FANUC HOUSE

1 STATION APPROACH, RUISLIP
ROOF PLAN
2088-P15 E

ROOF PLAN
1:100 @ A1

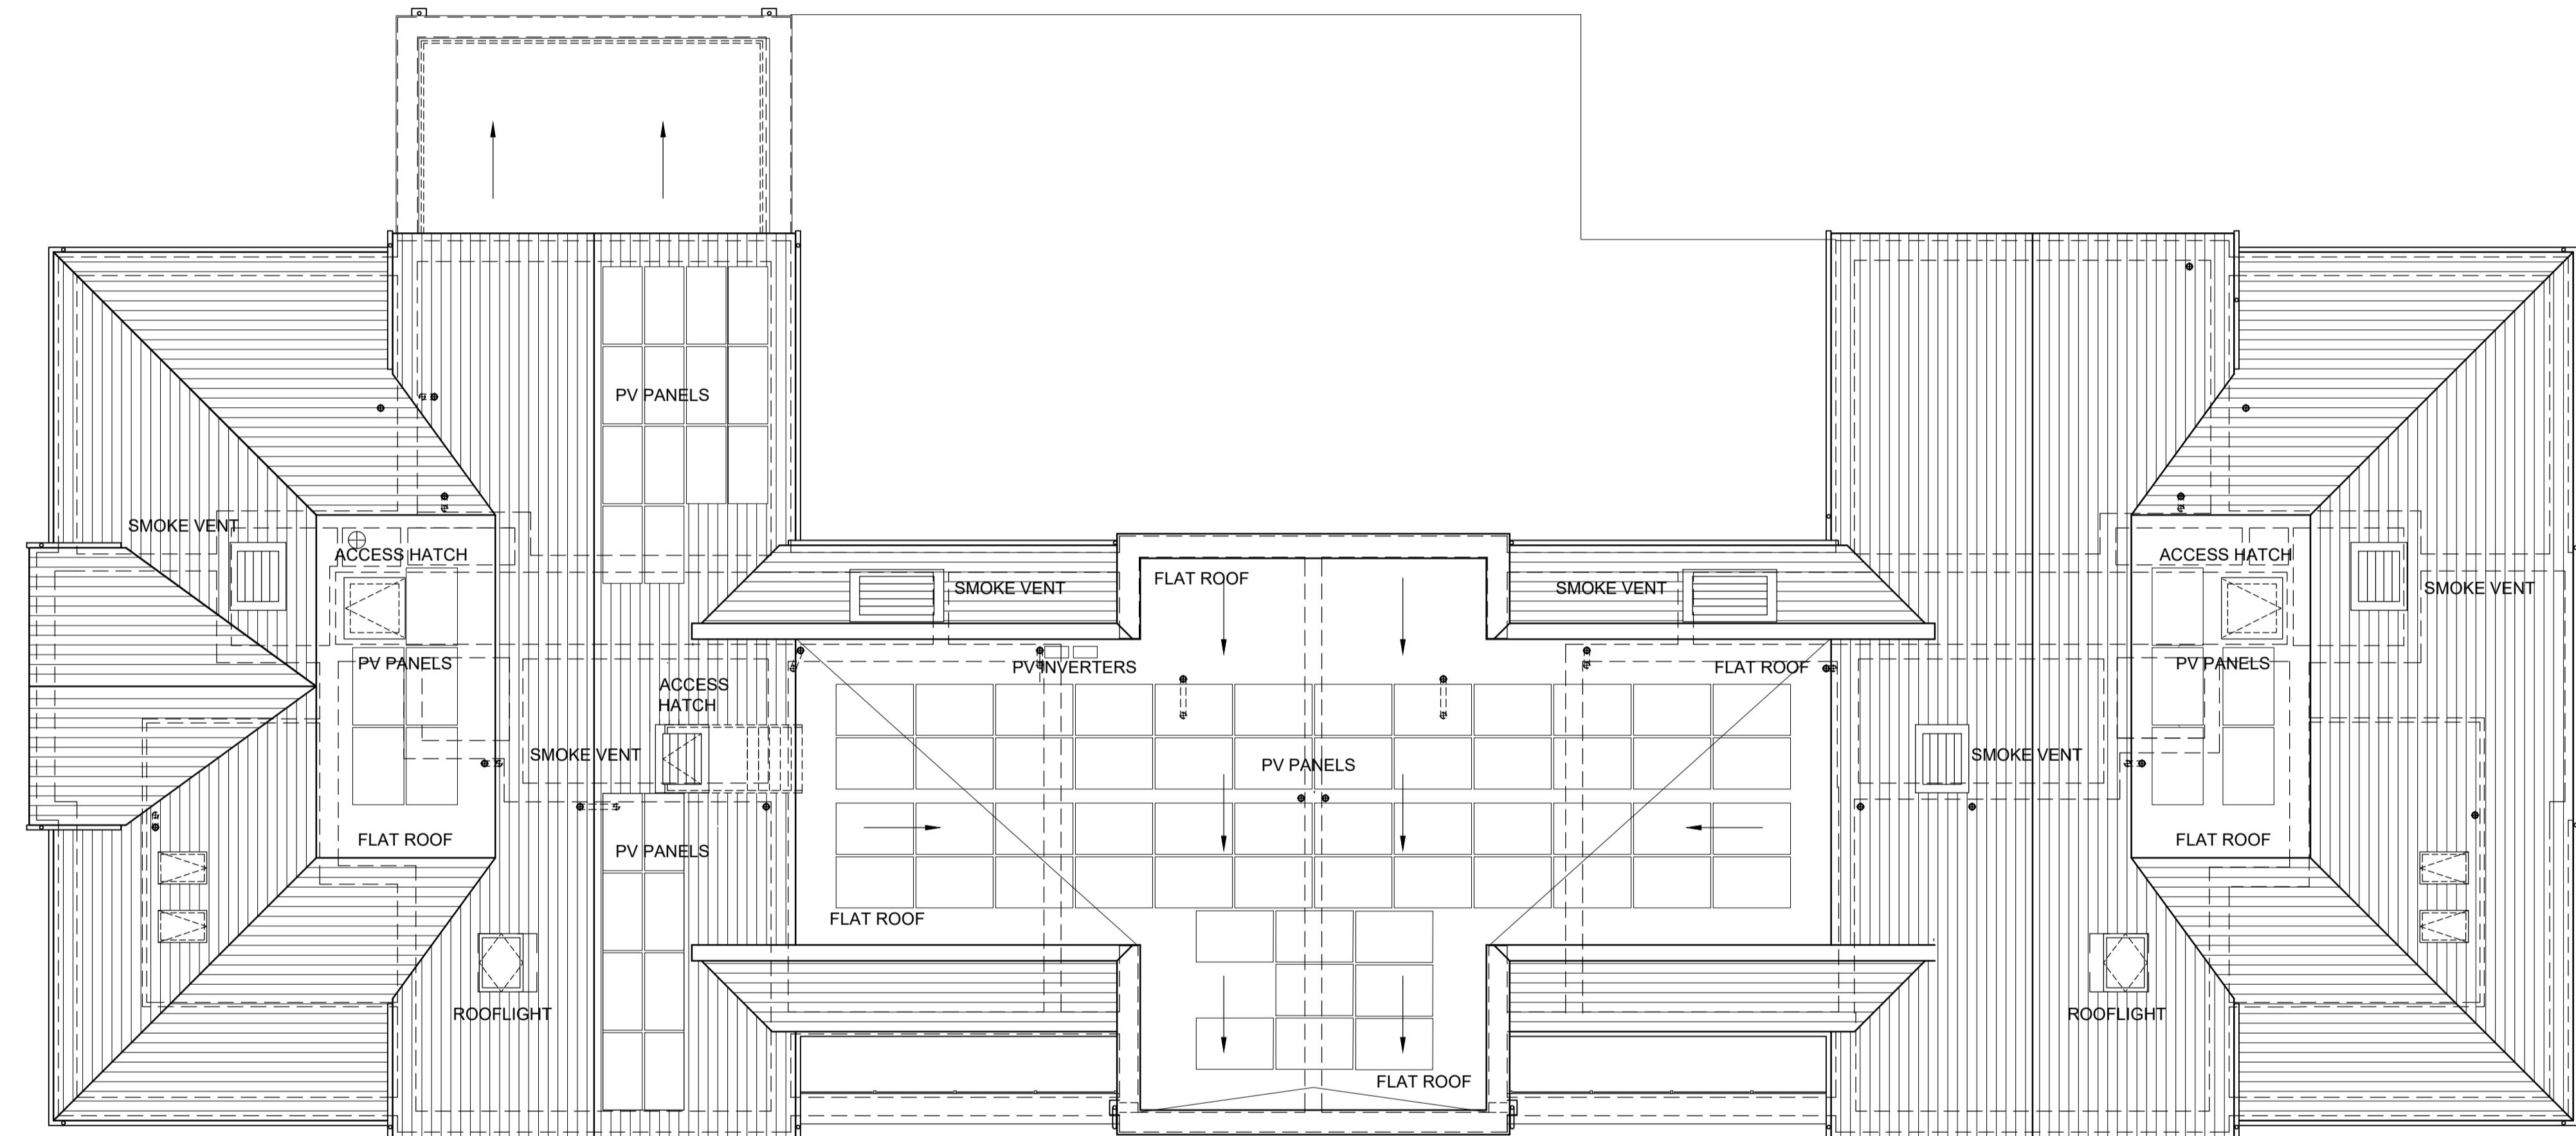
REVISIONS	DATE	DRN	REV
ROOF WINDOWS ADDED / AMENDED	22/06/18	JM	A
PV PANEL MOVED FROM NW TO NE ROOF	09/07/18	JM	B
PV PANEL MOVED FROM NW TO NE ROOF	09/07/18	JM	C
ROOLIGHTS OMITTED FROM N & S ROOFS	26/10/20	JM	D
ROOLIGHTS ADDED TO N & S ROOFS	05/11/20	JM	E
